Fed. Project No. BRM-0046(111)

**Route 1&9T (25)  
St. Paul's Viaduct Replacement  
Jersey City,  
Hudson County, New Jersey**

**Addendum to  
Environmental Assessment/  
Draft Section 4(f) Evaluation**

**May 2002**

**FIGURE G-1: PROPOSED PROJECT**

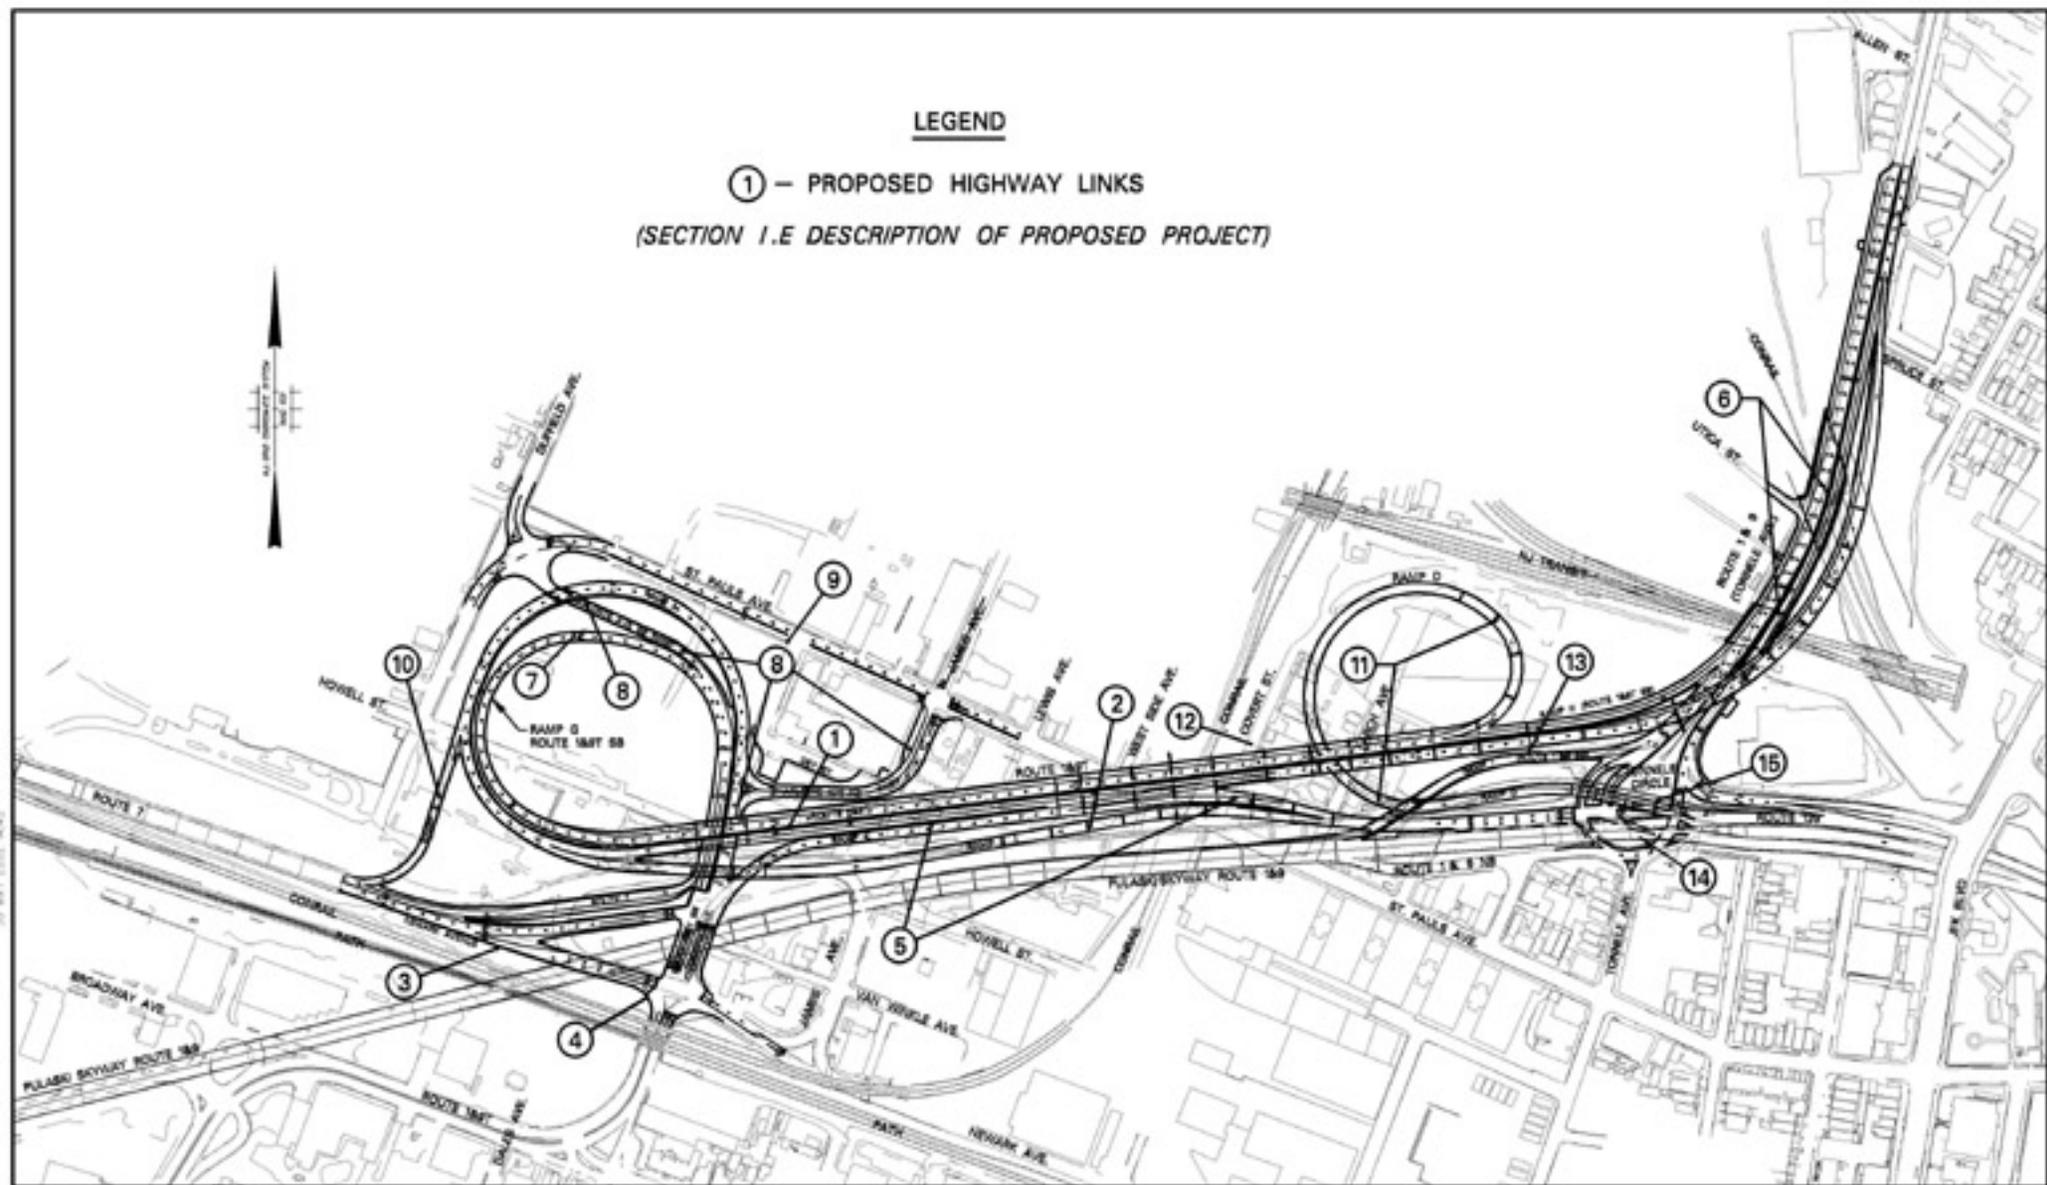
The proposed project, as shown in Figure G-1, would replace the Route 1&9T viaduct over St. Paul's Avenue with a new structure on a new alignment north of the present structure. The new alignment requires the construction of new approach roadways, which would provide connections to Route 1&9T, Route 7, Pulaski Skyway, Route 139, Route 1&9 north of Tonnele Circle, and local streets in Jersey City.

FIGURE G-2: PROPOSED PROJECT COMPONENTS  
Route 1 & 9T (25)

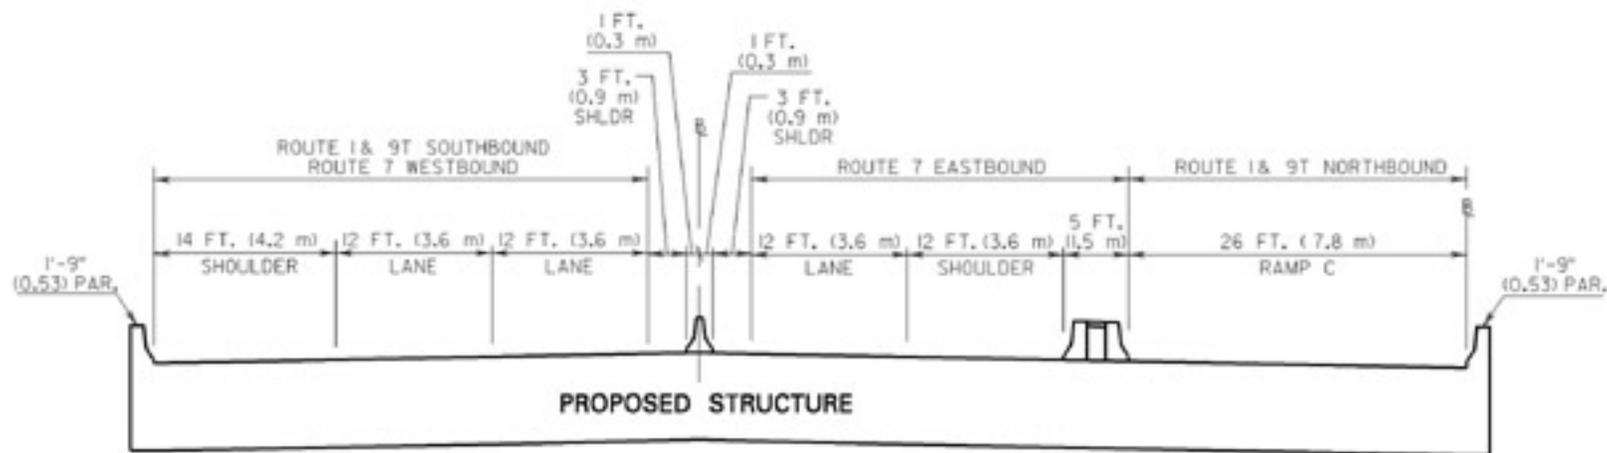
A number of structures, ramps, and other connections would be constructed or modified as part of the proposed project. All proposed ramp, lane, and shoulder widths would be designed in accordance with the NJDOT Roadway Design Manual. The components of the proposed project, as shown in Figure G-2, are as follows (with roadway directions abbreviated as NB, SB, EB, and WB). If a component description differs from that presented in the EA, the title is noted as “- (**Revised**).”

### **1. St. Paul's Avenue Viaduct – (Revised)**

From west to east, the mainline alignment would begin at the vicinity of the intersection of Route 7 and Charlotte Avenue (constructed under the Operational Improvements Project), with connections to Route 7, Route 1&9T, and St. Paul's Avenue. The planned alignment would proceed on a viaduct over Charlotte Avenue, St. Paul's Avenue, Conrail, and ultimately reach Route 1&9 northbound on a flyover structure that

## **2. Route 7 EB to Tonnele Circle/Route 139 (Holland Tunnel) via Ramp B-(Revised)**

From the mainline, Ramp B would exit west of Charlotte Avenue and pass over Charlotte Avenue and Ramp C, proceeding toward the existing connection at Tonnele Circle.

**5. Route 1&9T NB to Route 1&9 NB or Tonnele Circle/Route 139 via Ramp C- (Revised)**

Ramp C would replace the connection to the existing viaduct by collecting the traffic from Route 1&9T NB and from Route 7 EB. This replacement ramp would allow vehicles a choice of proceeding along the mainline to Route 1&9 NB (via the flyover ramp), or traveling into Tonnele Circle to connect with Route 139 EB (Holland Tunnel).

**7. Route 1&9T SB Loop Ramp (Ramp G) to Charlotte Avenue/Route 1&9T SB - (Revised)**

The proposed alignment would pass over the PSE&G sub-station to connect with Charlotte Avenue/Route 1&9T SB. The alignment requires the entire taking of the PSE&G property (bordering St. Paul's Avenue, Duffield Avenue, Howell Street, and Charlotte Avenue), which contains known environmental concerns. The proposed ramp would connect to Charlotte Avenue SB immediately north of the Route 1&9T/Newark Avenue intersection.

### **10. Ramp A- (Revised)**

Ramp A would ultimately be the Route 7 WB connection from Route 1&9T NB and from the local connection from St. Paul's Avenue. Ramp A would receive westbound traffic coming from St. Paul's Avenue via the new ramp (designated as "Charlotte Avenue NB Ramp") that starts at the intersection of James Avenue and St. Paul's Avenue. The new signalized intersection at St. Paul's Avenue and James Avenue would service the local Jersey City motorists destined for Route 7 WB. This portion of the relocated roadway is expected to carry a significant number of vehicles, which would access Route 7 WB and the Wittpenn Bridge via Ramp A.

TYPICAL SECTION  
ST. PAULS VIADUCT IN VICINITY  
OF JAMES AVENUE

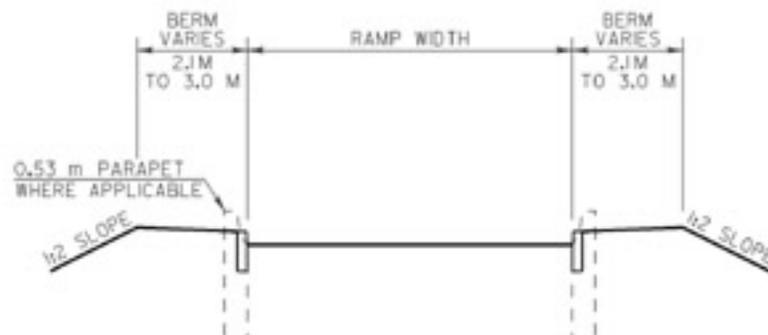
A typical roadway section for Ramp B would consist primarily of a 7.8m (26-foot) wide, one-lane structure until the connection is made with Ramp C. The connected Ramp B/C roadway typical would consist of one 3.9m (13-foot) lane, one 3.6m (12-foot) lane and one 3.9m (13-foot) lane, which proceed to the Tonnele circle. A typical ramp section is shown on Figure G-3.

The typical section for Ramp C would consist of a 9.6m (32-foot) wide, two-lane structure adjacent to the mainline EB structure. When the grade separation is reduced between these two structures they would combine into one structure west of the Conrail railroad tracks. To the east of the Conrail tracks, Ramp C would combine with Ramp B and pass under Ramp I to lead vehicles to the Tonnele circle. A typical ramp section is shown on Figure G-3.

The proposed Ramp D would pass over the Tonnele Circle, pass under Ramp I and the mainline Route 1&9T before tying into Route 1&9T SB lanes. The typical roadway section would consist of a 7.8m (26-foot) wide on-lane ramp, which would sit on both fill and on structure. A typical ramp section is shown on Figure G-3.

Ramp I would cross over loop Ramp D and the combined Ramp B/C before tying into the existing WB lanes of the Pulaski Skyway. The typical roadway section would consist of a 7.8m (26-foot) wide one-lane ramp, which would sit on both fill and on structure. A typical ramp section is shown on Figure G-3.

The proposed replacement of the structure would improve the underclearance at the Circle and would also allow for safety improvements by protecting the existing piers with new lane configurations and providing new locations for the proposed piers of the replacement structure. A typical section is shown on Figure G-3.
